**Planning and Land Use Department**  
**Planning Commission Staff Report**  
*AMENDED for Planning Commission Meeting 9/4/25*

<b>Case Number</b>	#2024-9320
<b>Hearing Date</b>	September 4, 2025
<b>Agent</b>	Pax Consulting
<b>Applicant</b>	Zydeco LLC
<b>Request</b>	Development Plan
<b>Location</b>	7205 Plaza Central, Santa Fe, NM 87507
<b>Case Manager</b>	Alexa Hempel
<b>Zoning</b>	C-1 (Office and Related Commercial)
<b>Overlay</b>	Suburban Archeological Review District
<b>Pre-App Meeting</b>	June 27, 2024
<b>ENN Meeting</b>	August 20 & September 30, 2024
<b>Proposal</b>	The Applicant requests approval of a development plan for up to 165 multi-family units with a clubhouse, swimming pool, and neighborhood coffee shop on a 7.9-acre parcel.

**Case #2024-9320. 7205 Plaza Central Development Plan.** Pax Consulting, Agent, for Zydeco LLC., Owner and Applicant (“Applicant”), requests approval of a Development Plan for up to 165 multifamily residential units, a clubhouse, swimming pool, and neighborhood coffee shop located at 7205 Plaza Central. The property consists of a 7.9-acre lot as the result of a future lot line adjustment, zoned C-1 (Office and Related Commercial). (Alexa Hempel

Figure 2: Drawing of the new proposed exterior of one building type on the property. See full plan sets in Attachment C.

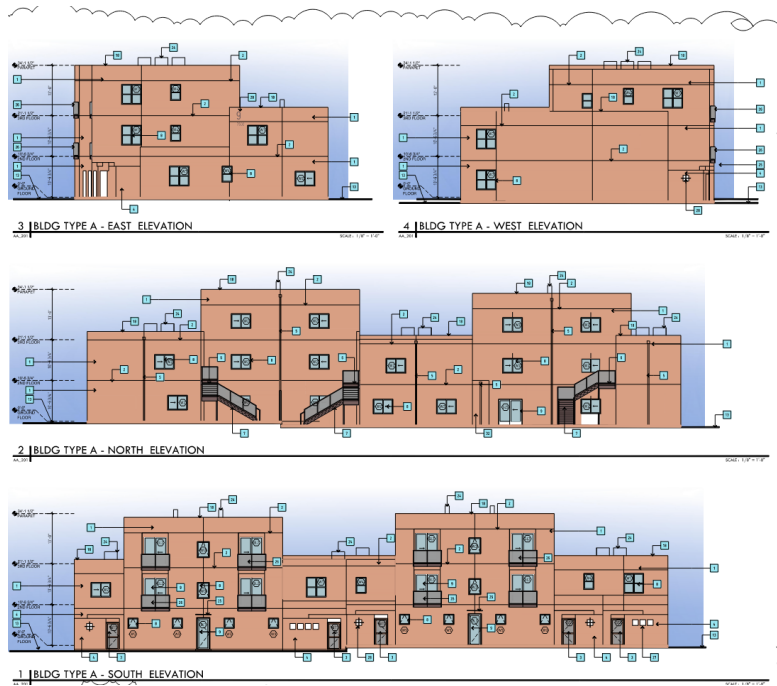
The Applicant originally proposed that the exterior stucco be painted a high-intensity colonial white with accent colors of green, gray, pink, and yellow. The Tierra Contenta Architectural Review Committee approved this proposed design, acknowledging that it deviated from the design guidelines for Phase 2C, while still meeting the intent of those guidelines. However, development plans within Tierra Contenta must go through additional City review to meet the requirements of SFCC Ch.14, which may only be interpreted by the Land Use Director after consultation with the City Attorney (SFCC 14-1.10).

SFCC 14-1.7(B) states that in the event conflicts arise between Chapter 14 and any other ordinance, resolution, or regulation, the more restrictive limitation or requirement shall prevail. In this case, Chapter 14 imposed more restrictive requirements. Staff determined that the proposed high-intensity colors did not meet the following, and therefore recommended denial for the August 7, 2025 hearing:

- Minimum 205 architectural points required for C-1 zoning;
- Development Plan Approval Criteria #3, which calls for adaptability and compatibility to properties in the vicinity; and
- Findings and Purpose of the Architectural Design Review (SFCC 14-8.7(A)), which calls for architecture outside the historic districts to maintain a degree of compatibility with architecture inside the historic districts.

Due to technological issues that led to a lack of quorum, the August 7, 2025 Planning Commission meeting was rescheduled to September 4, 2025. During that time, the Applicant changed the predominant color of the exterior stucco from colonial white to zona rosa – a terracotta color (See Figure 2). The Applicant also omitted the use of accent colors and submitted revised architectural drawings to reflect the exterior color changes (Attachment C).

The new design exceeds the 205 architectural points required for C-1 zoning and is compatible with the surrounding neighborhood as well as the architecture found within the City’s historic districts. Staff are now recommending approval as the application meets the required architectural points, development plan approval criteria #3, and the purpose of the architectural review guidelines.

Figure 5: Existing Conditions. Dark purple is the 30% or greater slope being disturbed by this development, 567 sq ft.

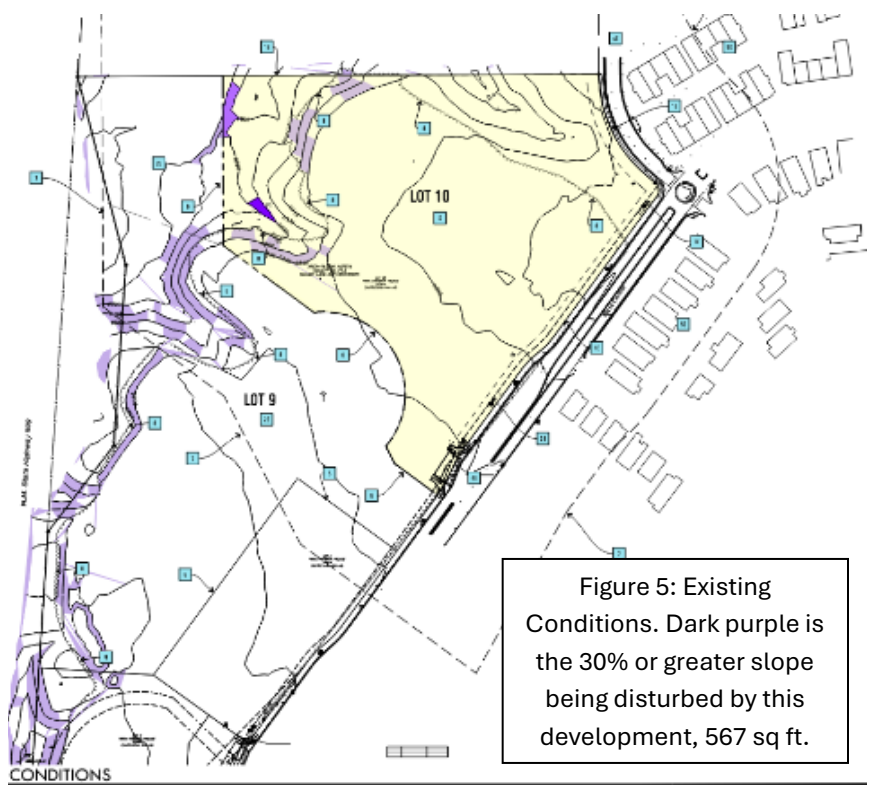
There are five locations of 30% or greater slopes within the development site (see Figure 5). Three of these are **manmade** and previously disturbed, totaling 7,140 sq ft. The remaining two areas are **natural** 30% or greater slopes. The natural sloped area in the northwest corner of the development site, totaling 1,381 sq ft, will remain undisturbed, while the other 567 sq ft area near the western boundary of the development site will be

disturbed for utility purposes, as allowed without the need for variance. The areas of 30% or greater slopes can be found on the existing conditions sheet of the development plan (see Attachment C).
